Charlotte Department of Transportation

Memorandum

Subject: Rezoning Petition 07-124: Located on the east side of South Tryon Street
between Doggett Street and Tremont Avenue
(revised 10/30/08)

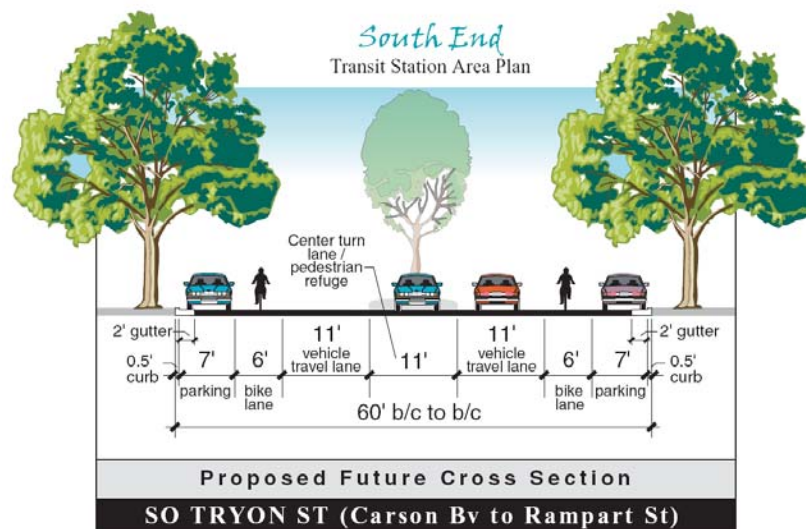
- Goal 1 of the TAP relies on the Centers, Corridors and Wedges land use strategy to be implemented. This project site is located in a Corridor and appears to support the Centers, Corridors and Wedges land use strategy.
- Goal 2 of the TAP describes various connectivity and design features that are important for motorists, pedestrians and bicyclists. Specific comments are identified below that need to be addressed for CDOT's support of the petition and to bring the site plan into compliance with the TAP and best practices for multimodal transportation.
